**A submission by Bryan G Norman BSc. (Est Man) for Deadline 6**

**Action Point 12. Planning Inspectors Action Points**

127642 A303 Sparkford

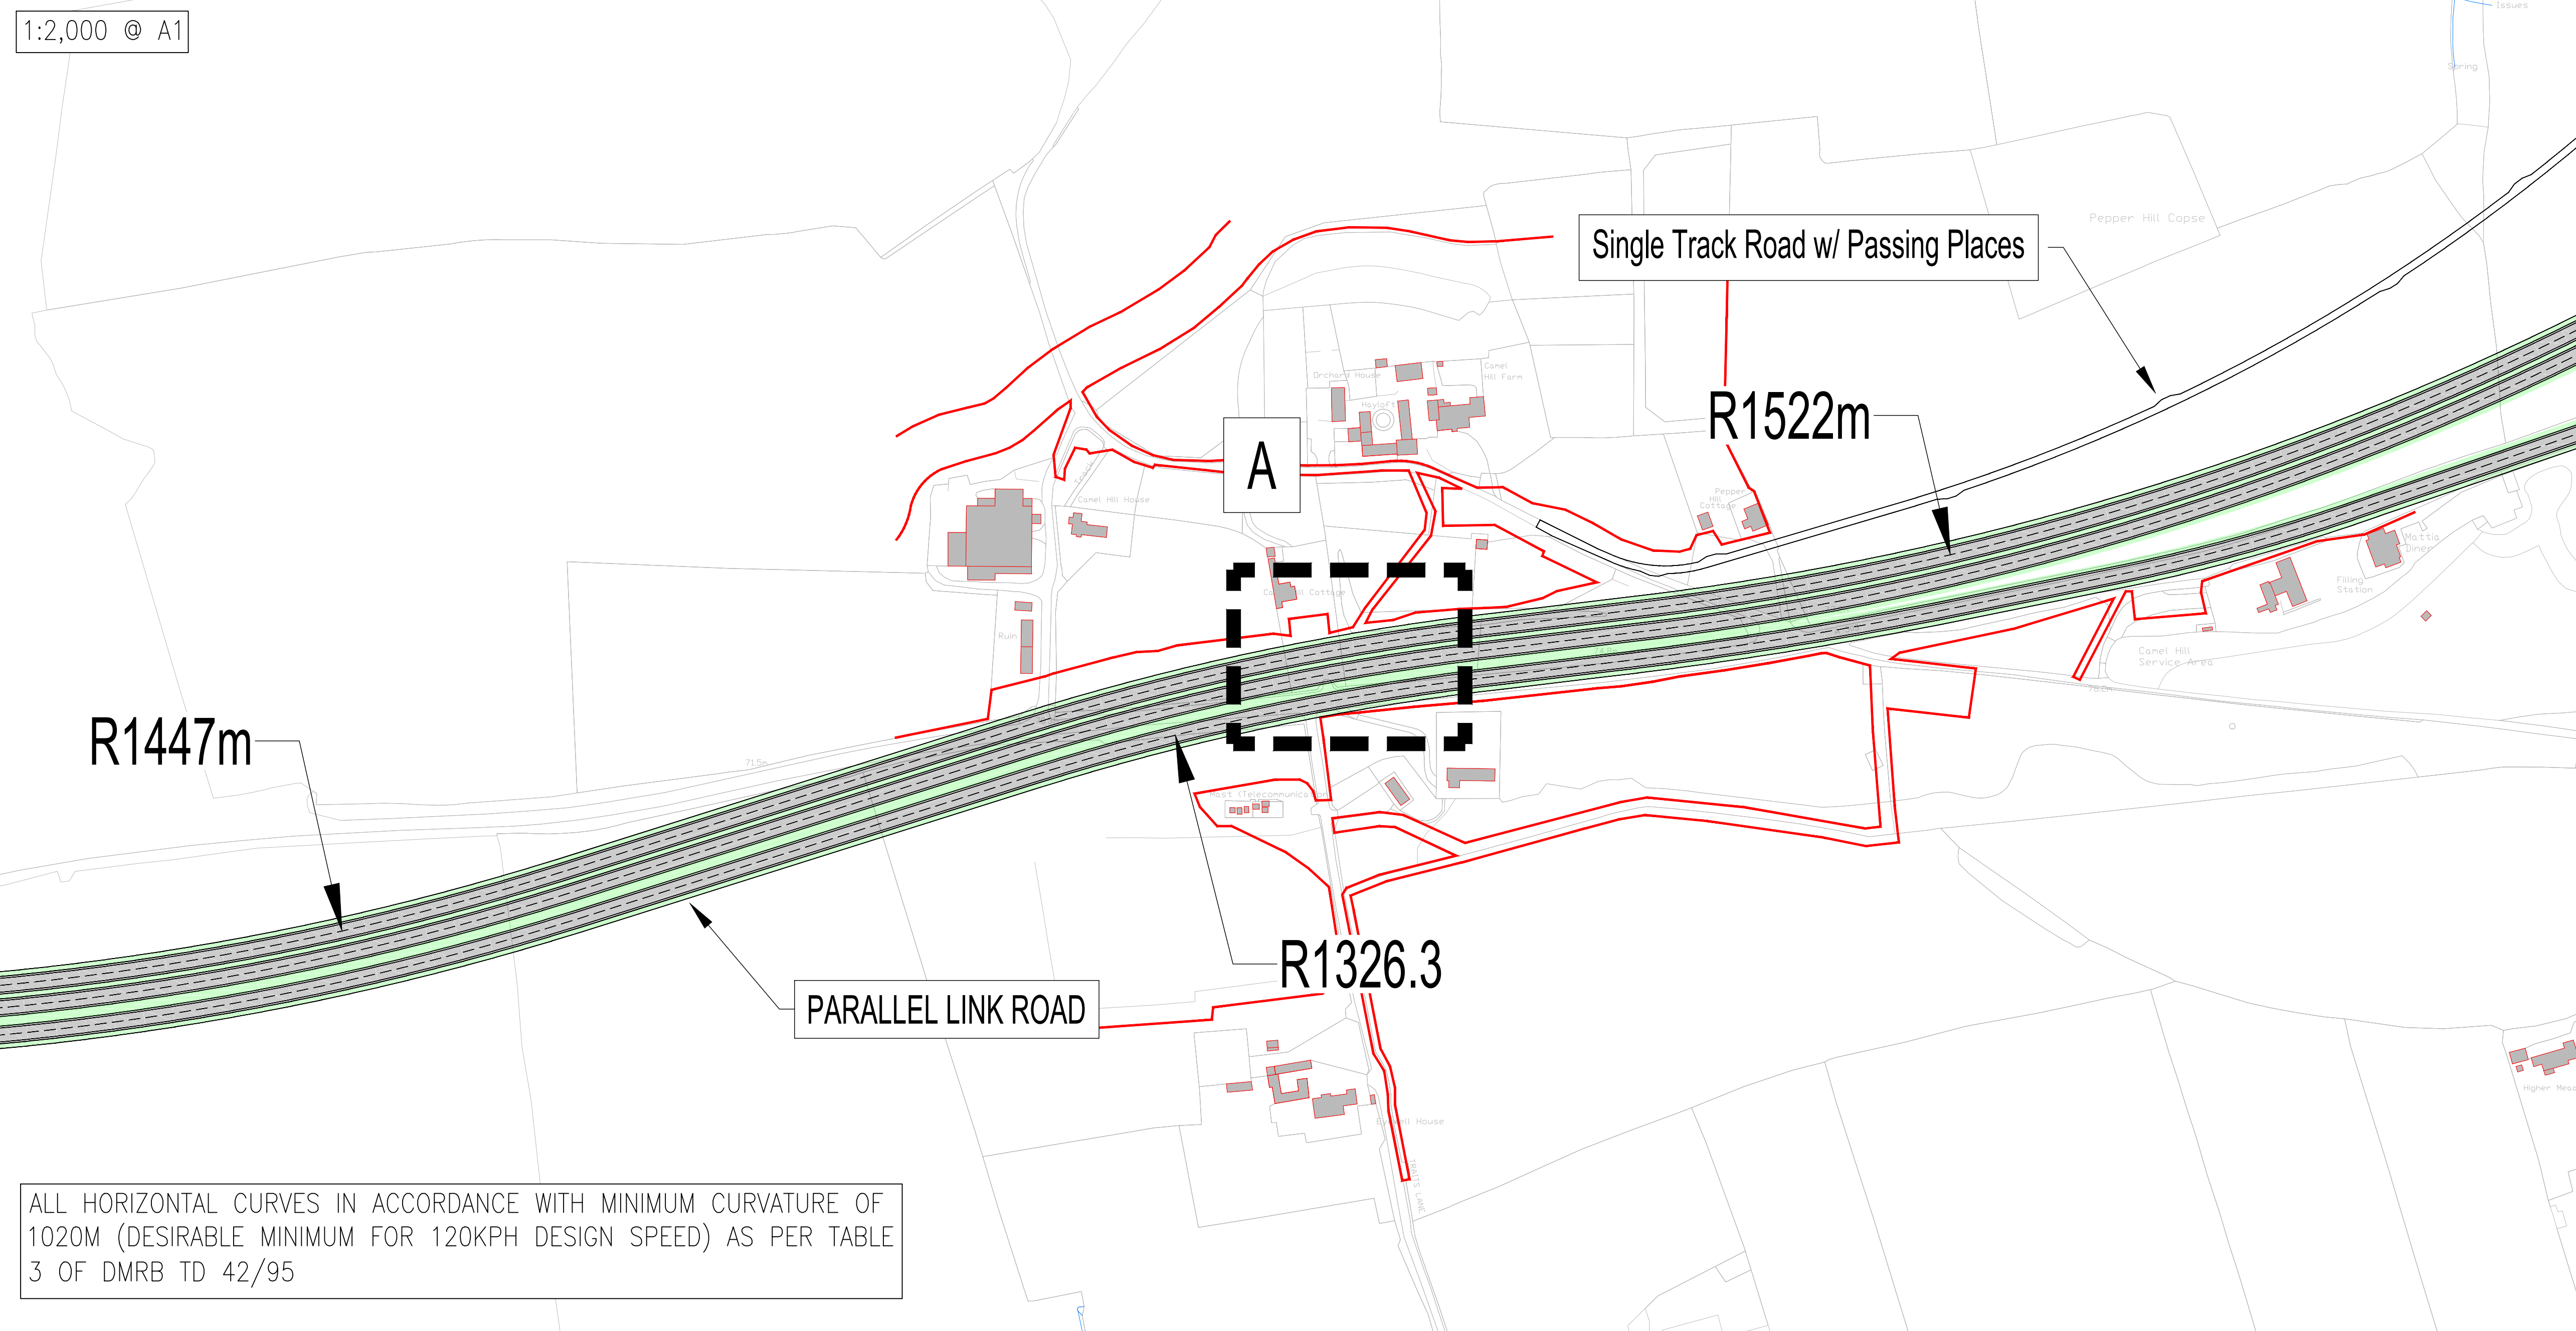
I attach copies of Fairhurst's letter (25/04/19) and their scaled drawing number 127642/1004 which shows that the PLR can be accommodated at the 'pinch point' at its full width of 7.3m and in compliance with all requirements of the MDRB, with a half metre safety margin for a visual barrier, without acquiring additional land from the MOD.

I've assessed our previous layouts against HE's comments and reviewed the relevant DMRB documentation. There's two key points to take away from this –

- Our hands are tied with regards to the width of the carriageway; the DMRB doesn't make any road width concessions that relate to either vehicle speed or traffic flows (the latter does apply in Scotland but unfortunately not in England).
- The main flexibility we have is with the horizontal alignment of the A303 and link road, rather than the actual width. The minimum corridor width is 40.4m; the main goal is therefore to try to align this so that it fits within the land constraints.

Based on the above I've revised the layout to take into account the minimum widths and horizontal curvature based on the design speed of the A303 (120kph). While the link road design speed is contestable it is ultimately constrained by the alignment of the A303 as the A303 has the higher speed.

The attached alternative layout includes the widths and curvature dimensions along with DMRB references to answer each of HE's comments.

EXAMPLE DIMENSIONED SECTION THROUGH A303 & PARALLEL LINK ROAD.  
ALL WIDTHS IN ACCORDANCE WITH DMRB TD27/05 FIGURE 4.3a

ALL HORIZONTAL CURVES IN ACCORDANCE WITH MINIMUM CURVATURE OF 1020M (DESIRABLE MINIMUM FOR 120KPH DESIGN SPEED) AS PER TABLE 3 OF DMRB TD 42/95
